# DRAFT AIA Document G701™ - 2001

## Change Order

**PROJECT (Name and address):**  
Radcliff Elementary School Renovation  
- Phase 3  
1145 S. Dixie Boulevard  
Radcliff, Kentucky 40160

**CHANGE ORDER NUMBER:** 005

P1.2A

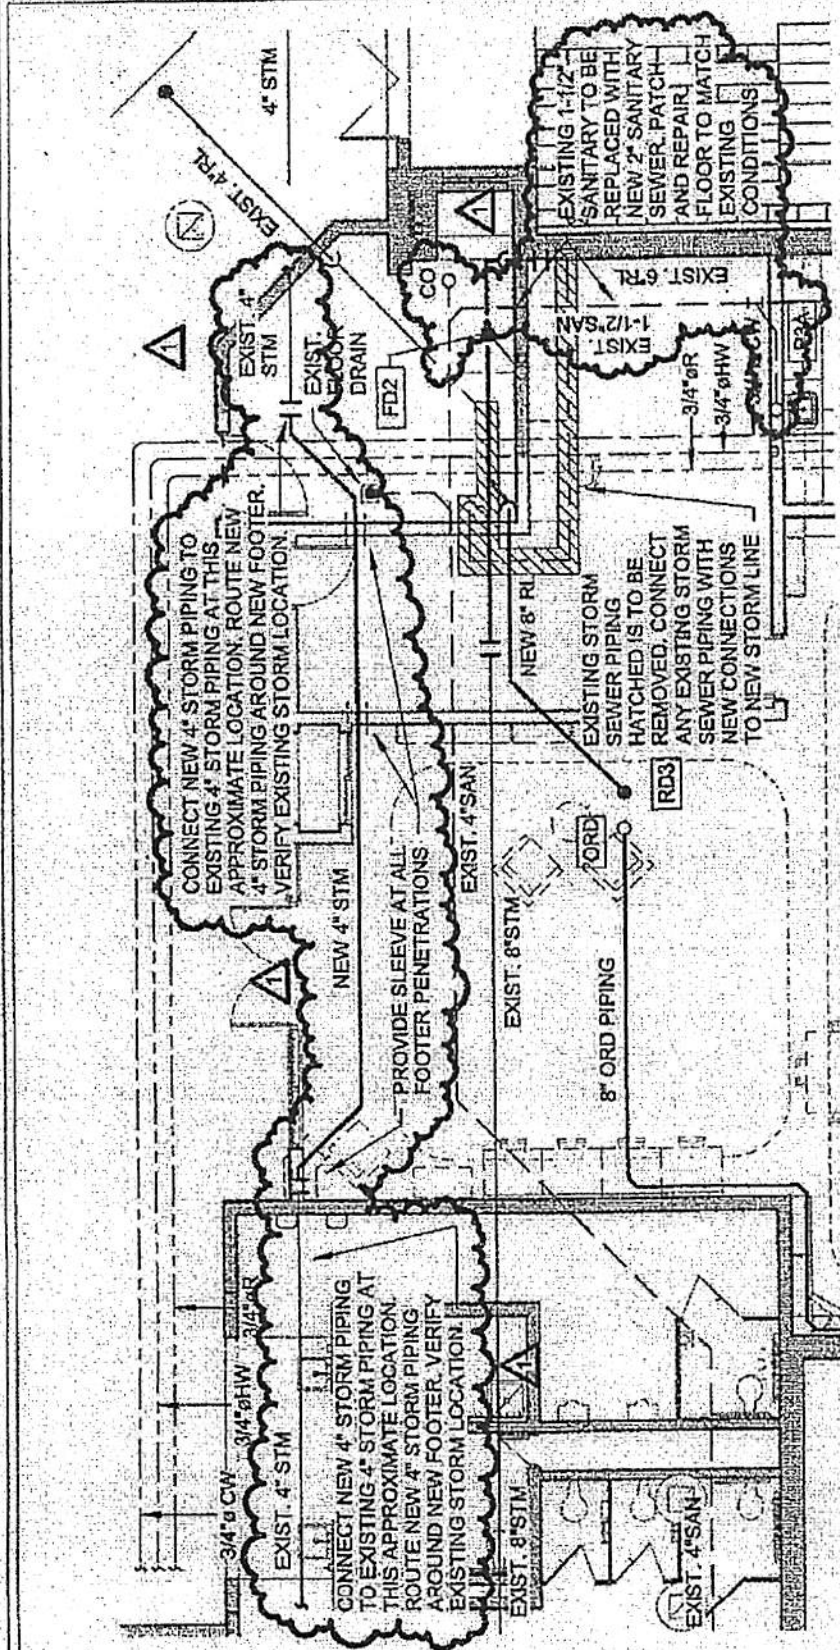
Provide material and labor cost for the relocation of an existing interior 4" storm line adjacent to the existing Media Center, to avoid foundations for new interior wall partitions. This existing storm line drains the existing interior courtyard. All pipe penetrations through the foundations shall be sleeved. Refer to attached drawing.

Also remove existing 1-1/2" sanitary line as indicated on the attached drawing, and install new 2" sanitary line as required per Kentucky Plumbing Code. Patch and repair existing floor to receive new finishes. Existing construction documents indicated an existing 3" sanitary line; however, upon demolition, the line was found to be 1-1/2". Per Kentucky Plumbing Code, minimum of 2" sanitary line shall be provided under slab.
